**PROPOSED TECHNICAL
SPECIFICATIONS**

Technical Specification 5.0

"DESIGN FEATURES"

FIGURE 5.1.B-1

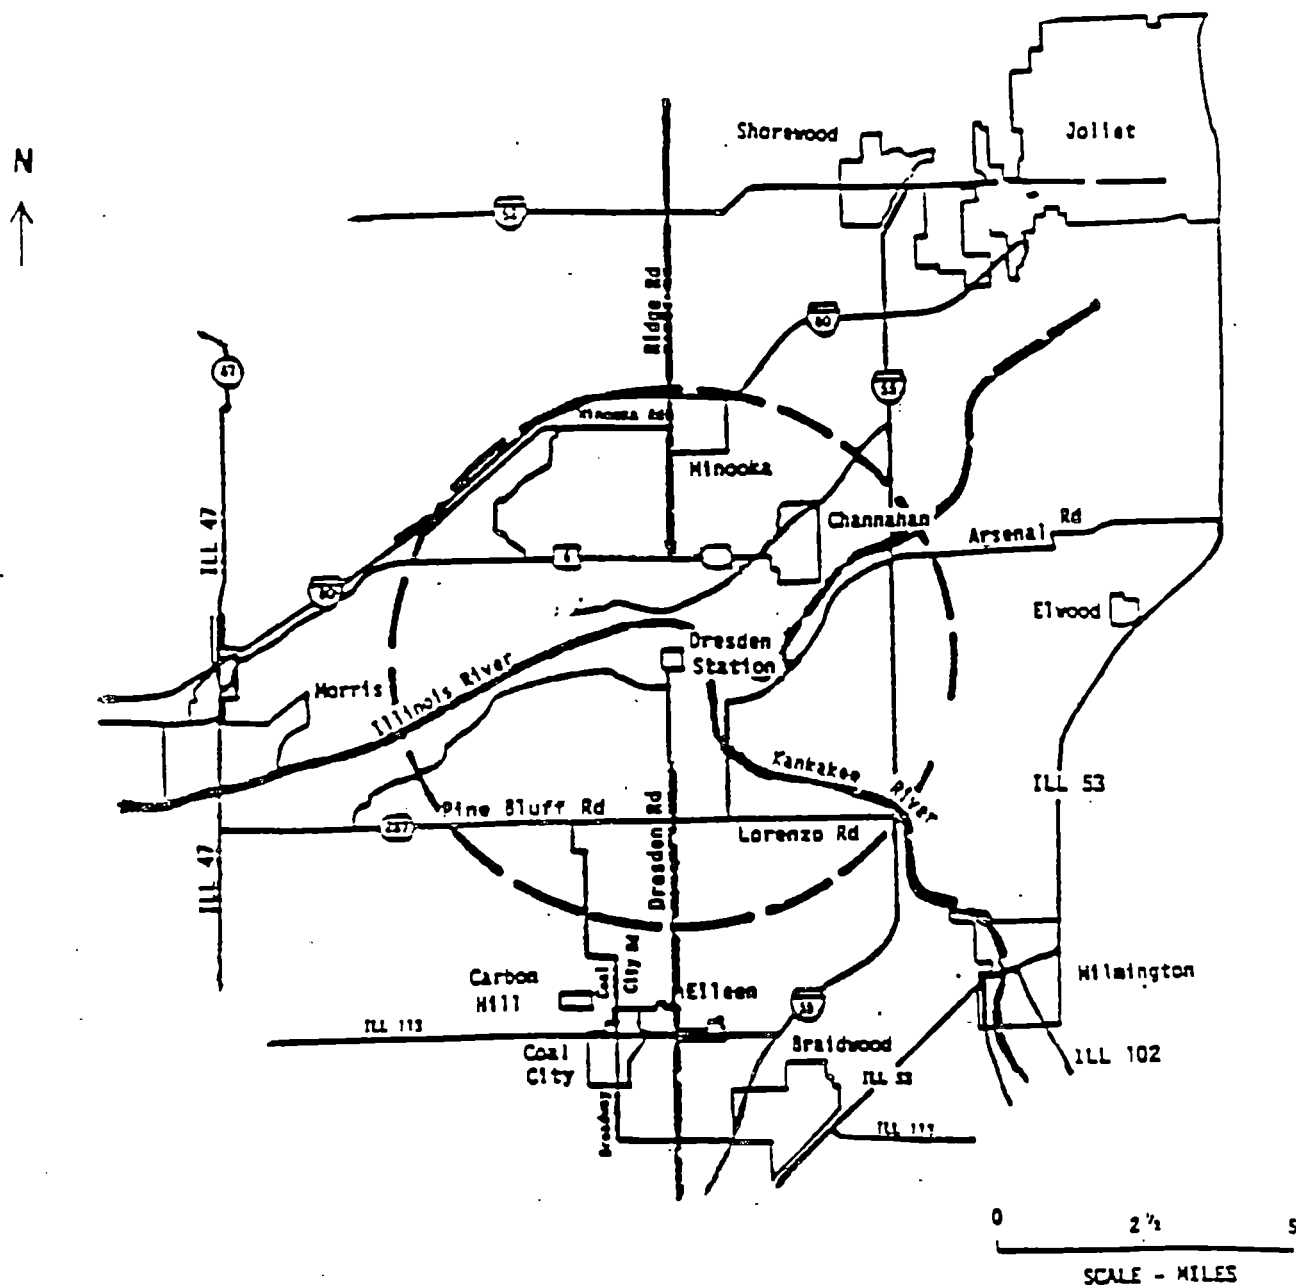
5.1.B The low population zone shall be as shown in Figure 5.1.B-1.
